30 April 2021

**RE: AMENDING DEVELOPMENT APPLICATION AND RESPONSE TO SUBMISSIONS - DA 10646 for SEPP 64  
ADVERTISING SIGNAGE PROPOSED AT SUSSEX STREET, SYDNEY**

**Figure 2 Photomontage of previous southern sign**

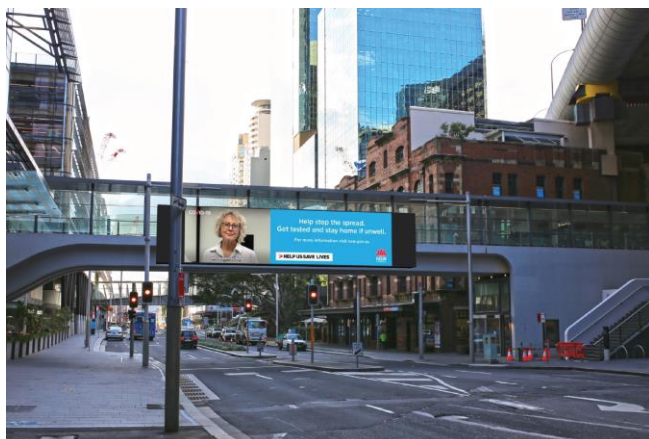
The application is proposed to be amended to remove the northern sign, and reduce the size of the southern sign. As such, the amended DA now only seeks approval for the installation of one digital advertising sign proposed at the southern elevation of the existing bridge. Signage supporting structure including framework, wiring, electrical and communications is also maintained as proposed for the southern sign.

The proposed amendment results in a reduction in size of the southern sign to comprise a visual display board of 8.3m in width and 2.2m in height (an area of 18.26m<sup>2</sup>). The revised visual display board will continue to sit atop an aluminium composite material (ACM) cladded backing, which is proposed to be revised to 8.4m in width and 2.3m in height.

**Figure 5: Viewpoint 1**

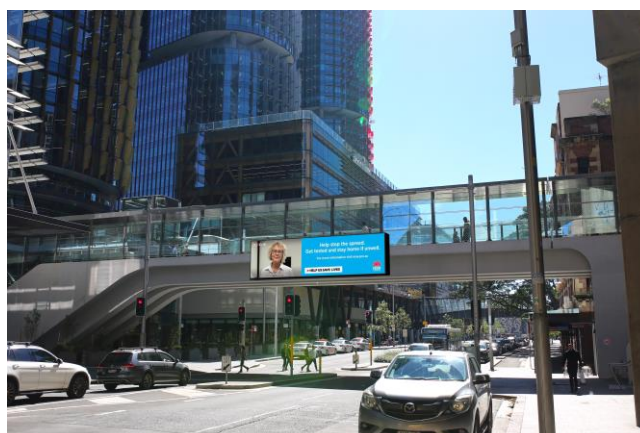
These views indicate that the sign forms part of the broader context of the area, particularly as seen from Viewpoints 3 and 4 from a distance, with the existing Western Distributor overpass in the foreground which provides for an infrastructure heavy environment. As moving closer to the sign, as shown in Viewpoints 1 and 2, the sign is not overbearing of the environment, rather sits within the modern characteristics of the area, particularly the Barangaroo towers to the west and the modern 207 Kent Street tower sitting behind the heritage item to the east.

In terms of magnitude, the proposal is considered to be low as it fits comfortably within the context of the existing land uses. The land to which the proposal applies to is an infrastructure setting, positioned on Wynyard walkway with road infrastructure such as Sussex Street directly below and the Western Distributor to the north east. This is particularly evident in Viewpoints 1, 3 and 4.
